**Panel Report**

**Colac Otway Planning Scheme Amendment C90**

**Deans Creek and Barongarook Creek Flood controls**

**4 March 2020**

**Figure 2: Pixelated mapping and post exhibition Smoothed Mapping**

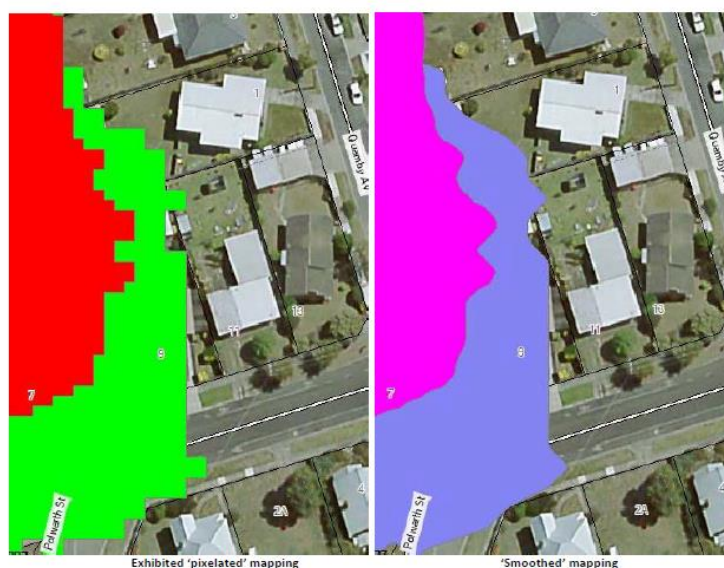
In regard to the issues raised in submissions about the accuracy of the LSIO and FO mapping, Council and the CCMA closely examined the mapping supplied in the *Deans Creek and Barongarook Creek Flood Study (August 2017)* by BMT WBM at an individual lot level. Council submitted that this process discovered that the mapping boundaries were of a pixelated nature that were somewhat cumbersome and artificial and not reflective of natural flood boundaries. The Council stated:

Following exhibition, FME (Feature Manipulation Engine) computer software was used to smooth the flood extents as per Melbourne Water Technical Specifications. This process made the mapping more realistic, legible and workable, and resulted in very minor changes to the mapping. No new properties were included in the amendment as a result of this process.

An example of this process is shown below in Figure 2.

## **Appendix C Panel agreed post exhibition changes to LSIO Schedule**

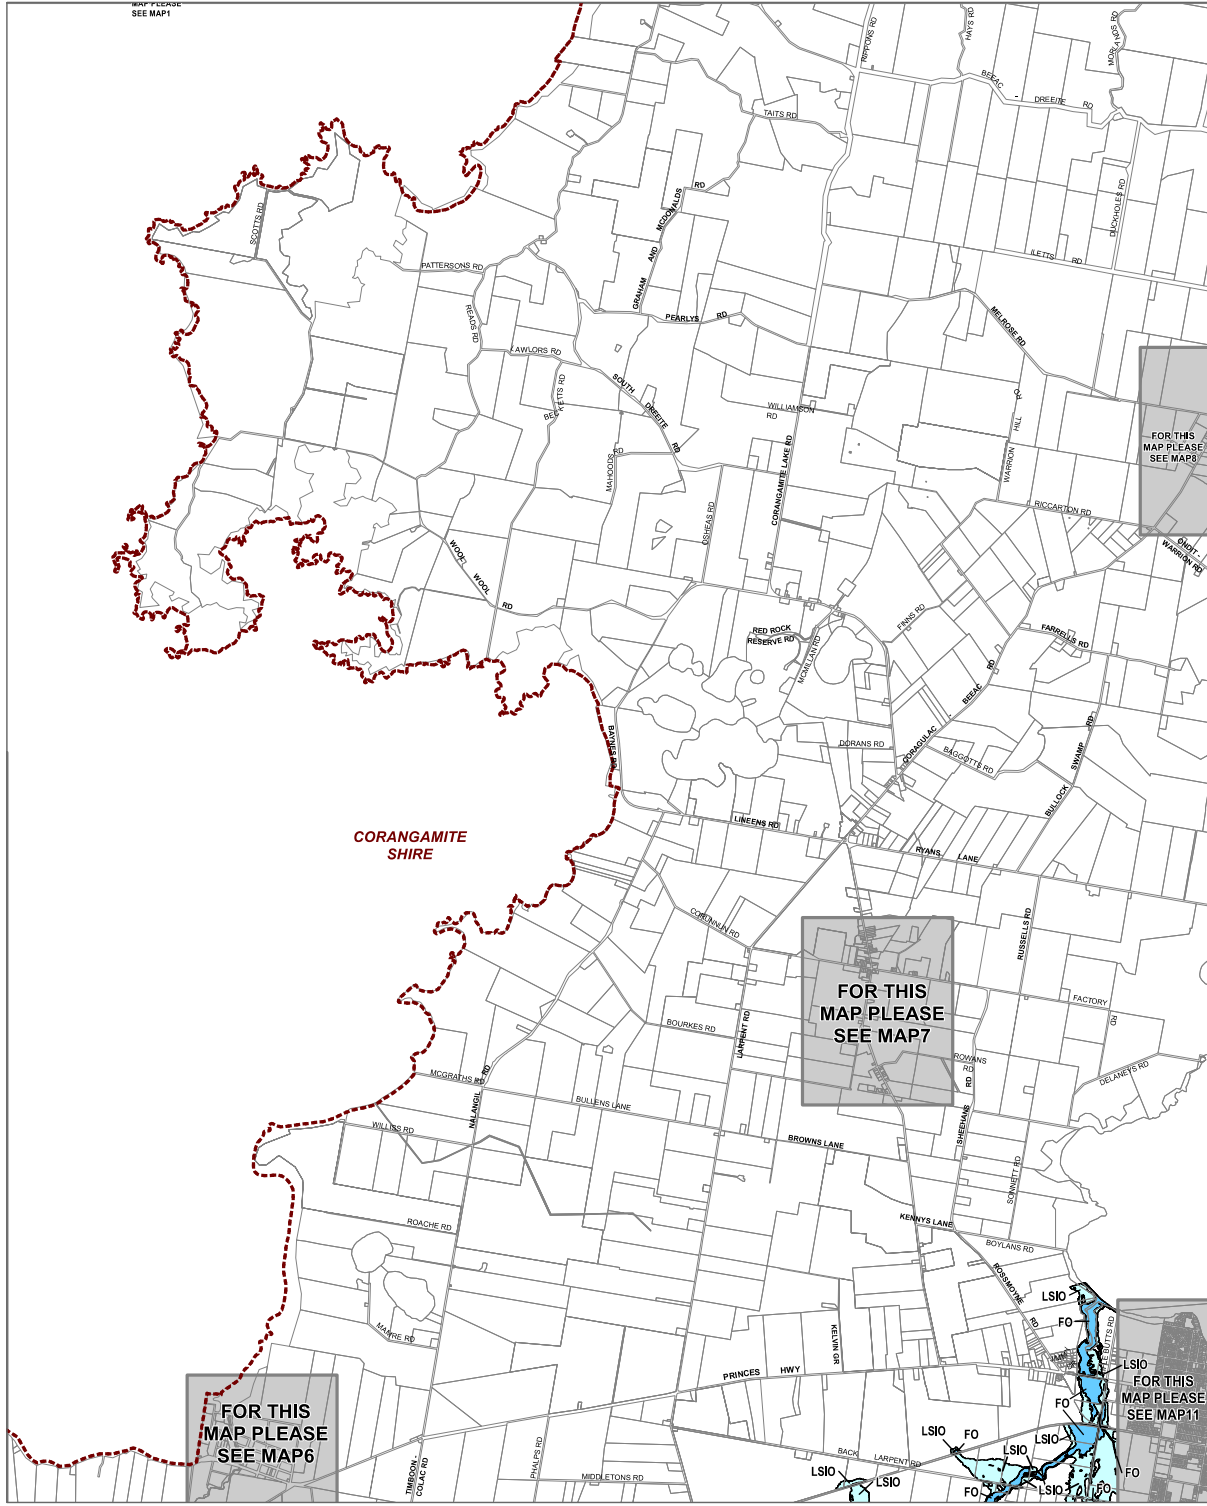
Following concerns raised in some land owner submissions, Council and the CCMA agreed to a revised LSIO Schedule which states that a planning permit would not be required for the development of a dwelling in the LSIO, providing the finished floor level is built 300 millimetres above the applicable flood level, the building is constructed on stumps or piers and that cladding to the subfloor has openings to allow for the passage of flood waters.

Council submitted the following post exhibition changes to the LSIO Schedule which have been agreed with the CCMA:

**~~Replacement Buildings~~**

- ~~▪ If the footprint of the replacement building(s) is the same or less than the original building(s), and~~
- ~~▪ If the floor level of the building is finished at least 300 mm above the 100 year ARI flood level, and~~
- ~~▪ If the replacement building is constructed on stumps (or piers) and bearers, and~~
- ~~▪ Cladding to the subfloor structure of the extension has openings or is of an open style (such as spaced timber boards) to allow automatic entry and exit of flood water for all floods up to the 1 per cent AEP event.~~

**New buildings, including extensions**

- If the floor level of the building is finished at least 300 mm above the 100 year ARI flood level and meets the safety hazard of FMA, and
- If the new building is constructed on stumps (or piers) and bearers, and
- Cladding to the subfloor structure of the extension has openings or is of an open style (such as spaced timber boards) to allow automatic entry and exit of flood water for all floods up to the 1 per cent AEP event, and
- Earthworks including any driveways, paths or services that do not alter the natural ground level.

**MAP No 15LSIO-FO**

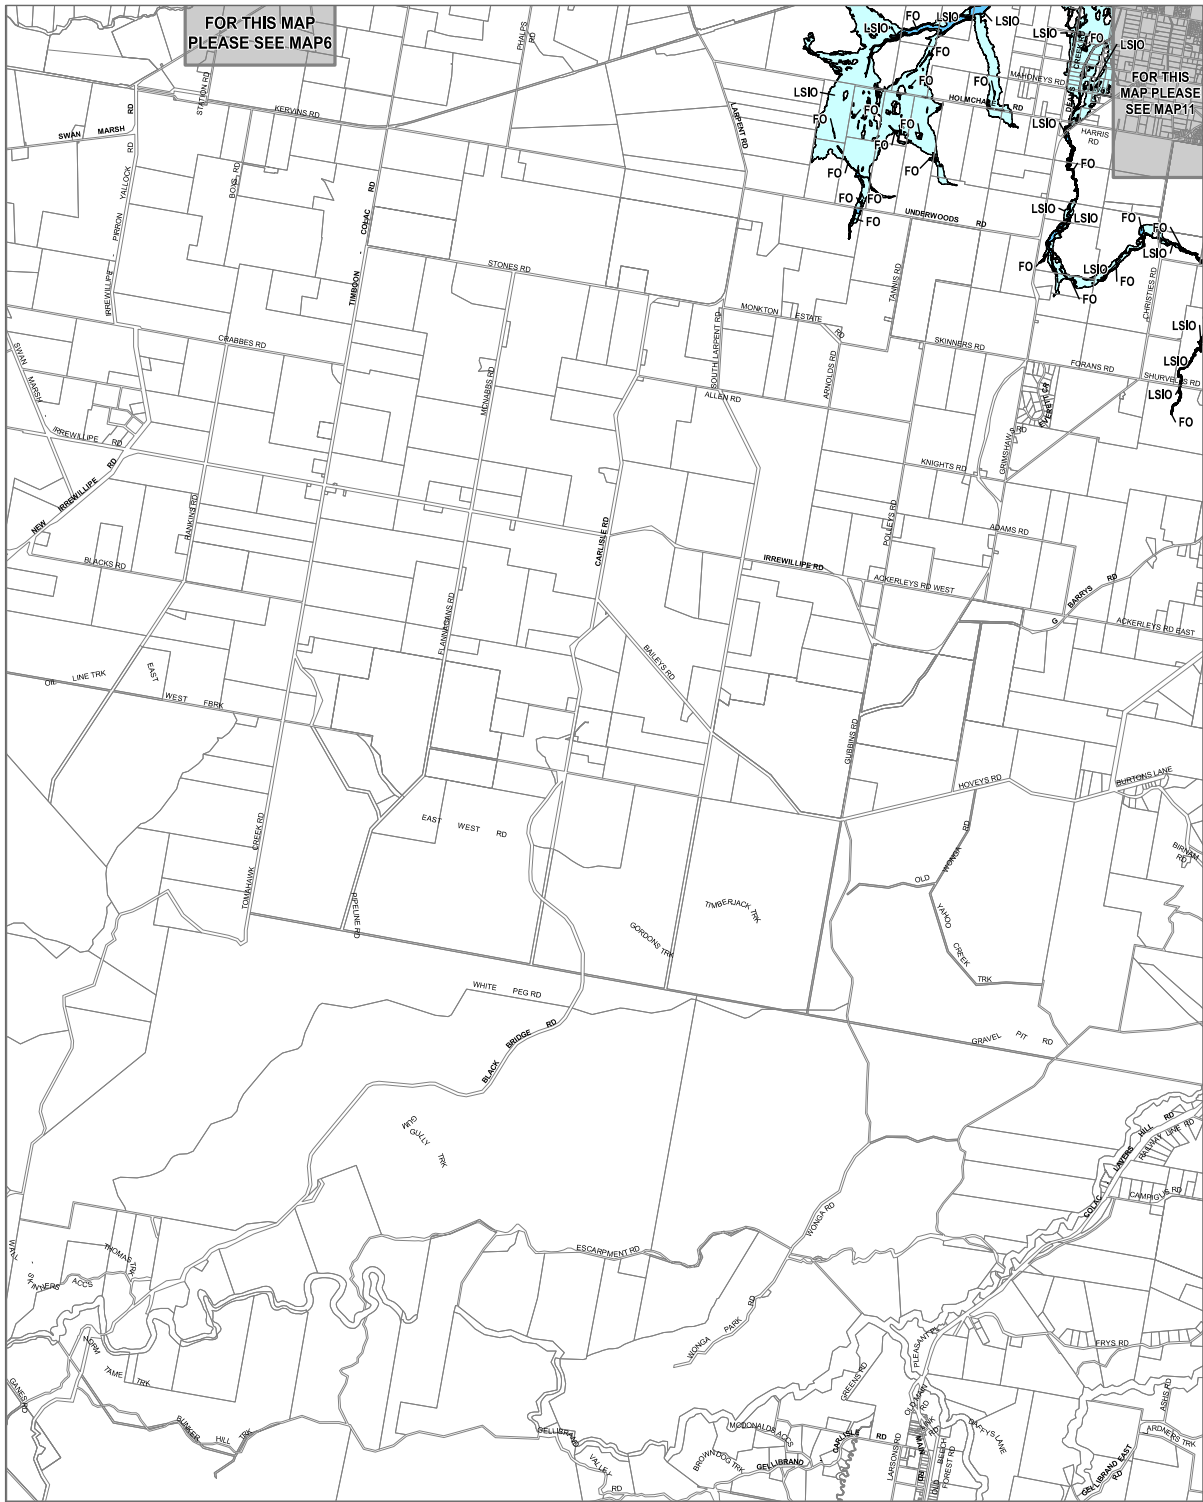
The Panel notes the undertaking by both Council and the CCMA to resolve submissions, in particular those of landowners that had small slivers, or islands, of land that were proposed to be subject to the FO and LSIO. This has resulted in revised FO and LSIO mapping, some

**Adopt Amendment C90 as per the agreed post exhibition changes to the LSIO and FO mapping as provided in Appendix D to this report.**
